# ENVIRONMENTAL REVIEW TEAM REPORT

## SPOONER HILL ESTATES KENT, CONNECTICUT

JULY 1980

FIGURE 2.  
**SIMPLIFIED SITE PLAN**

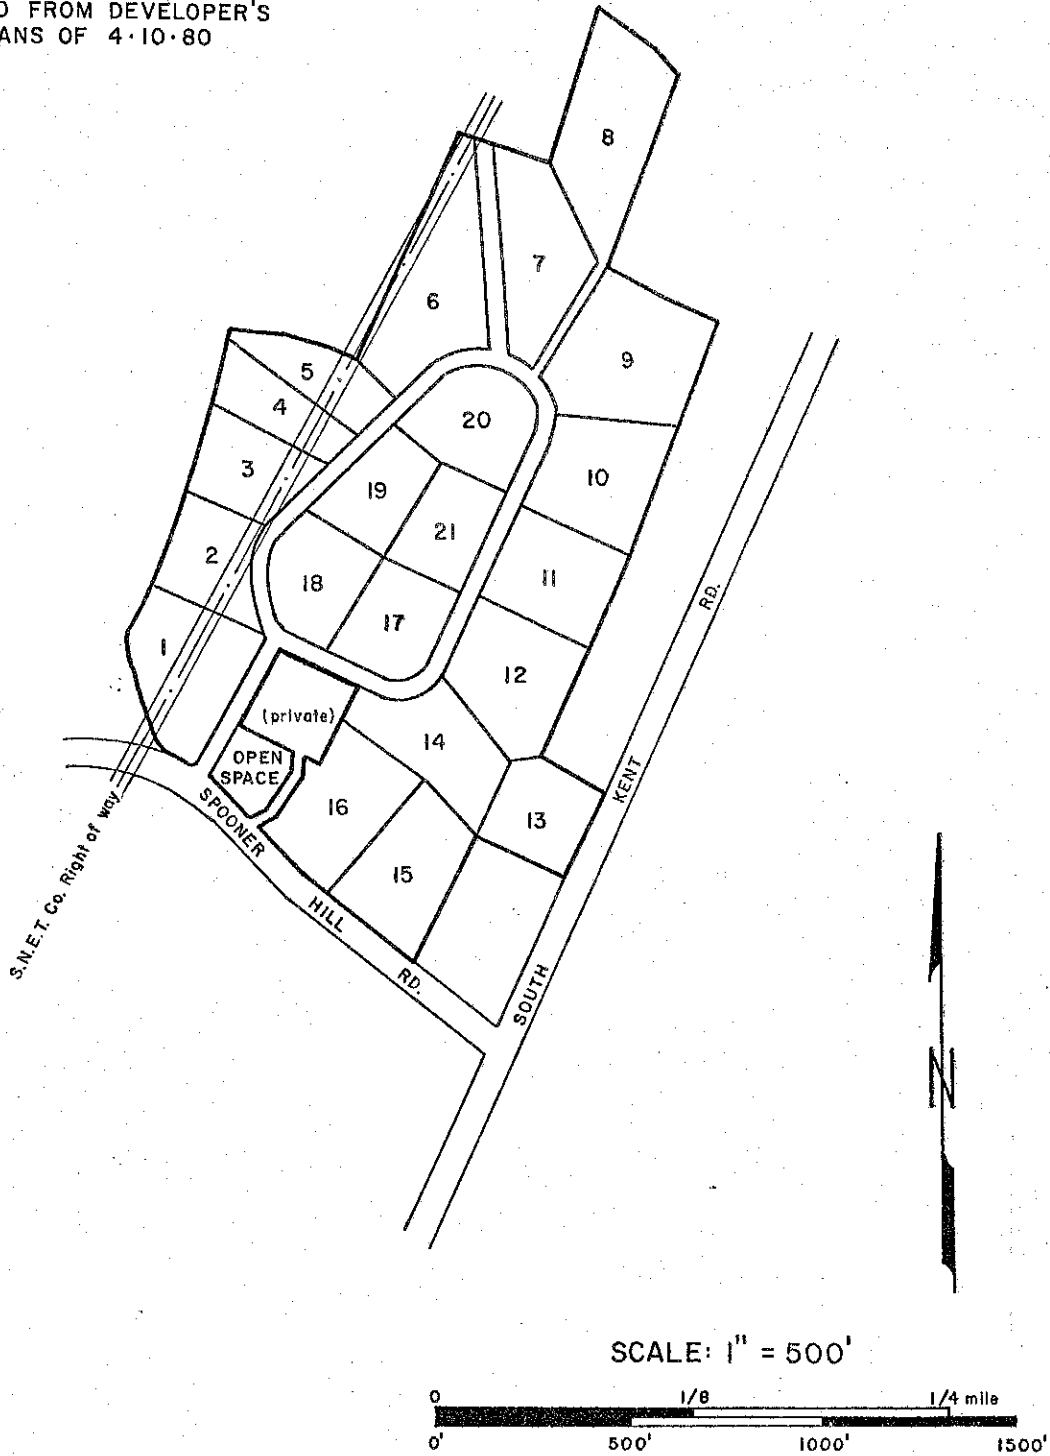
FOR THE INTERIOR LOOP ROAD: The road is proposed to cross this soil area and intermittent stream at two locations. At both locations, filling is indicated on the road profiles which should minimize the hazards of frost heaving of the road and the need for subsurface drainage.

Road water is proposed to be gathered by means of conventional catch basins and piping. Outlets are proposed at 4 different locations.

Energy dissipators at culvert outlets would decrease the potential of downstream erosion. Consideration should be given to providing some means of storm-water retention (see Hydrology section of this report).

1. The topography and soils on lots 2, 3, 4, 5, 13, and 18 appear to be conducive to the installation of subsurface sewage disposal systems with no serious limitations. It is suggested that leaching fields on these lots be installed as shallow as possible in order to utilize the upper sandy loam layers. This should reduce the risk of high groundwater interference and provide for better renovation of the septic tank effluent.

2. Due to a high groundwater table and/or a shallow depth to ledge rock condition lots 6, 8, 12, 14, 17 and 20 should be required to have subsurface sewage disposal systems designed by a qualified professional engineer prior to the issuance of a building permit. Although limitations exist, it appears that these lots can successfully support subsurface sewage disposal systems if the systems are properly designed.

3. On lot 1 the reported test pit was conducted in a swale beside a seasonal pond. This area does not appear adequate for subsurface sewage disposal. The area proposed for the sewage system should be tested and a reserve leaching area should be shown on the plan.

4. Neither lots 9 or 10 had been tested at the time of the ERT's field review. Both of these lots appeared to have some major constraints in finding an adequate location for a leaching area. The noticeable constraints were steep slopes and ledge rock outcrops in the vicinity of the proposed leaching system. Further testing should be conducted to delineate an area of suitable soil, and the location of all rock outcrops in the proposed leaching area should be shown on the plans. Preparation of two foot contours in the leaching area would also be desirable.

5. On lots 7, 11, 15, 16, 19 and 21 the soil as reported appeared to be adequate for subsurface sewage disposal. Site investigation however, indicated that some major constraints existed in installation of the leaching systems as proposed. It appears that the soil test pits were conducted in low swales or basins where adequate amounts of natural soil existed. Areas in close proximity to these tests were characterized by either ledge rock outcrops and/or topography that did not appear to be conducive to the installation of a subsurface

sewage disposal system. On these lots, further deep hole tests or probings should be required to delineate an area for a leaching system where an adequate amount of soil exists. It is also suggested that two foot contour intervals be shown in the area of the proposed leaching system as well as the location of any nearby or down gradient ledge rock outcrops.

The applicant has proposed a subdivision road to serve nineteen lots. Grades have been proposed in excess of 12%. This should be reviewed in great detail to insure provision of safe passage for all types of emergency service equipment. This is critical since there is only one access to this subdivision. The applicant has provided for future road extension to service the table lands north of the property. This is commendable, however such provision indicates that it is even more critical that the subdivision road proposed here be as safe as possible.

Sight distance inadequacy is limited on this project to one area along Spooner Hill Road looking southwesterly at the exit of the subdivision road. Investigation should be made as to the amount of clearing on the Spooner Hill Road right of way that can be made to improve sight distance to the minimum 350 feet required. If necessary, discussion should be held with the adjacent property owner for possible clearing on private land.

FIGURE 4.

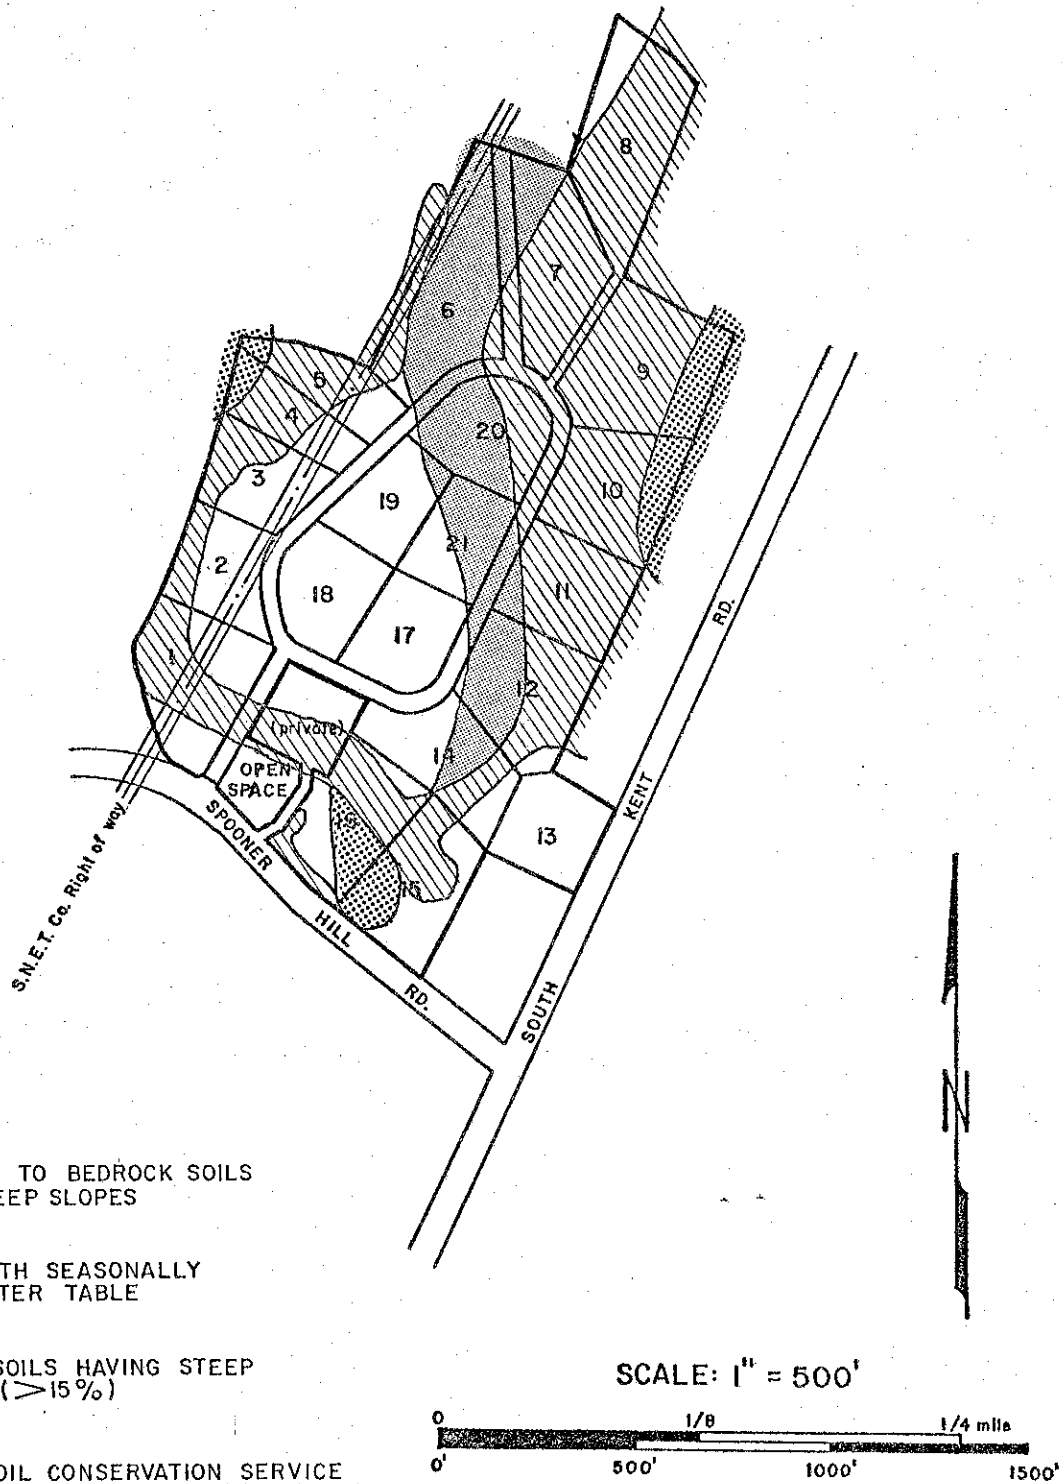
The limitations for subdivision development on this Hollis soil are all severe to very severe, i.e.:

FOR THE INTERIOR LOOP ROAD: Construction through the Hollis soil areas will be very costly because blasting will be required in order to establish proper grades.

FOR ON-SITE SEWAGE DISPOSAL SYSTEMS: Shallowness to bedrock and steepness of slope severely restricts installation and proper operation. Only by detailed examination can the location and extent of scattered deeper soils be located. Seepage on bedrock and into bedrock cracks can pollute water sources. The soil in general has a very low potential rating for on-site sewage disposal systems. The soil is suitable as woodland-its present use.

FOR HOMES WITH BASEMENTS: Excavation limitations are severe. Blasting is commonly necessary. In some places, lateral seepage is a hazard when water cannot move downward through cracks in the rocks. Footing drains are necessary in these places.

FIGURE 5.  
DRAINAGE AREA OF THE CULVERT AT THE INTERSECTION  
OF SPOONER HILL ROAD AND SOUTH KENT ROAD

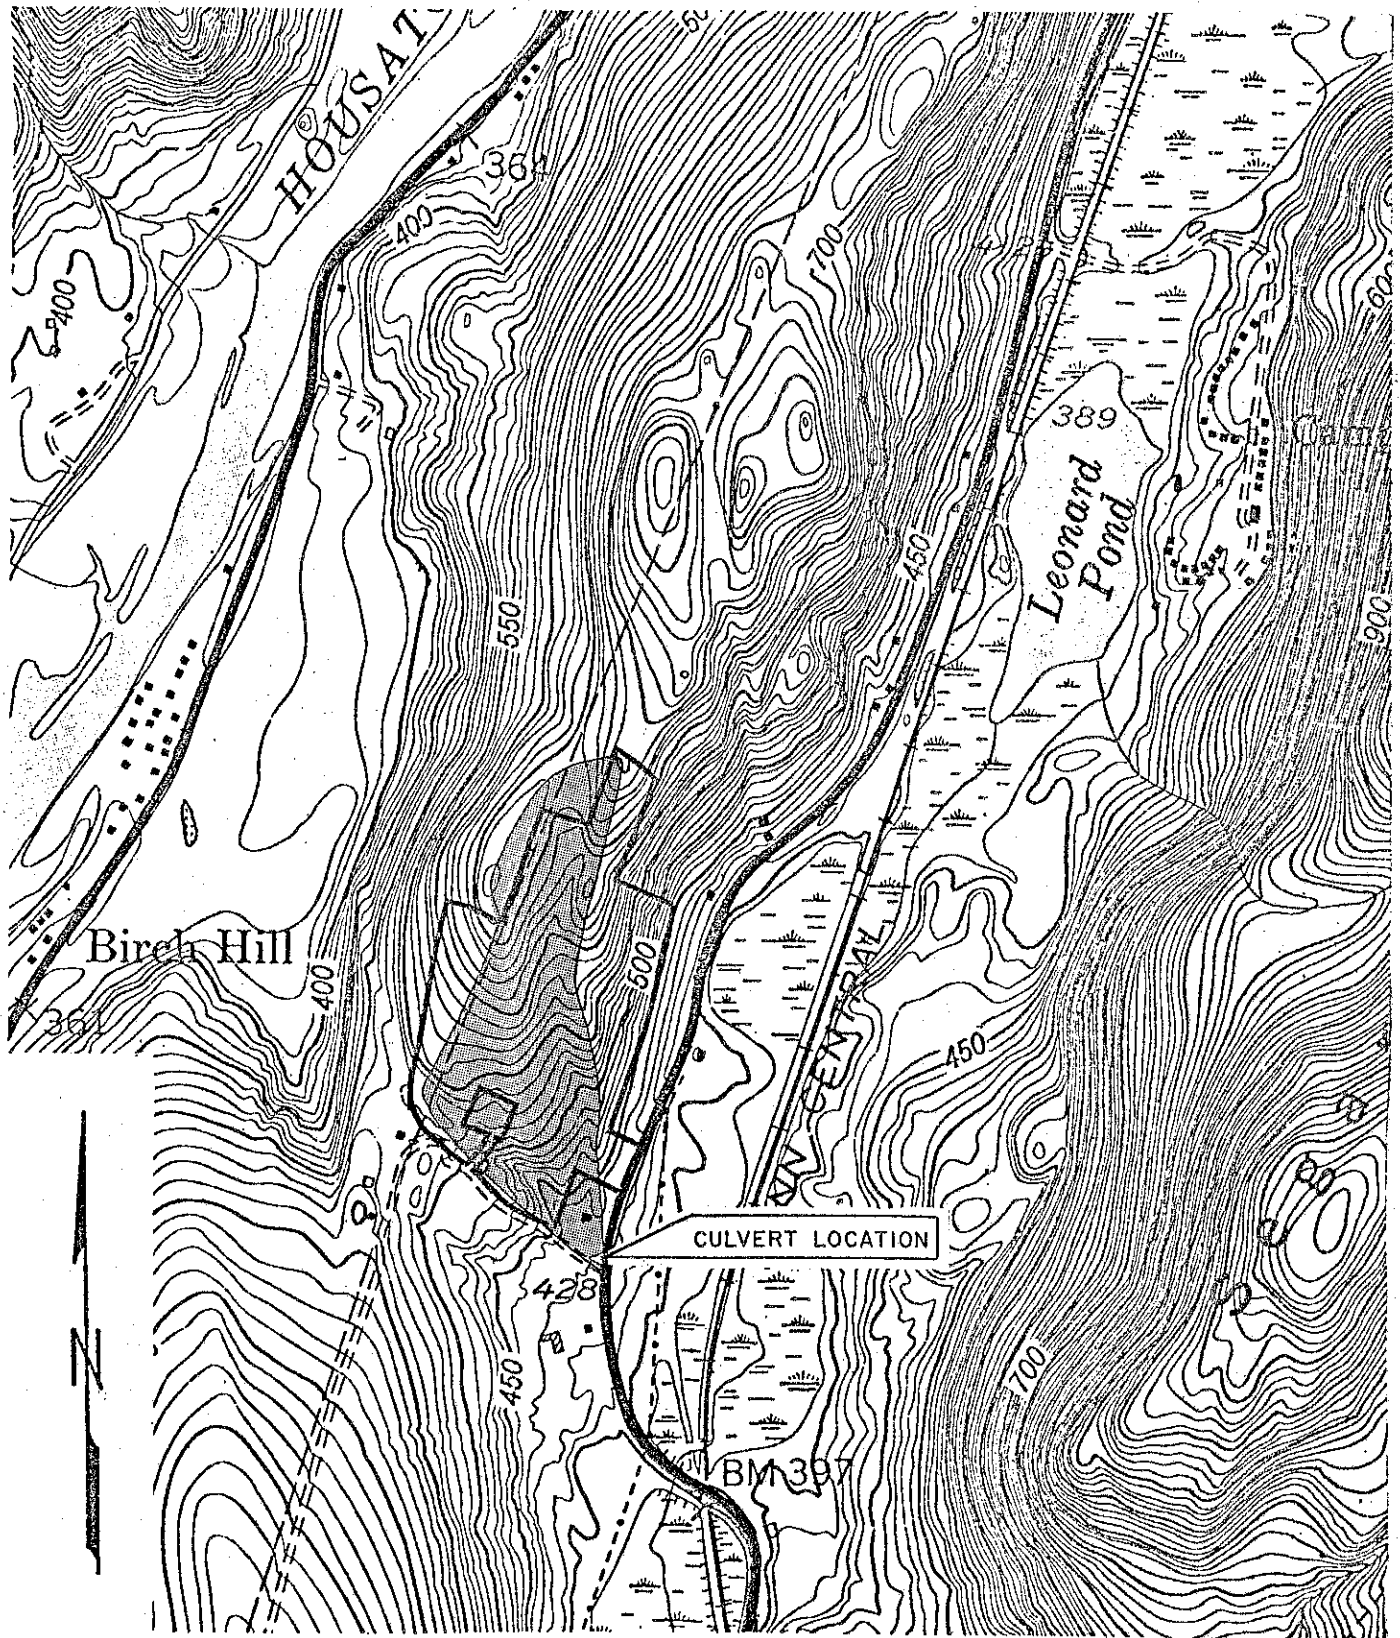
The projected peak flow increases are substantial, despite the relatively large lot sizes, because of the small overall size of the drainage area and the fact that development would occur virtually throughout that area. The most serious concerns these potential increases raise are: 1) the extent to which erosion of soils would occur, particularly along the central streamcourse on the site, and 2) the possibility of flooding in portions of lots adjacent to the central streamcourse. Erosion on both sides of the culvert may also be a problem, as may sedimentation either on the present corner lot or in the field across the highway. It seems clear that a serious effort should be made to develop adequate erosion and peak-flow controls in conjunction with the subdivision of this site.
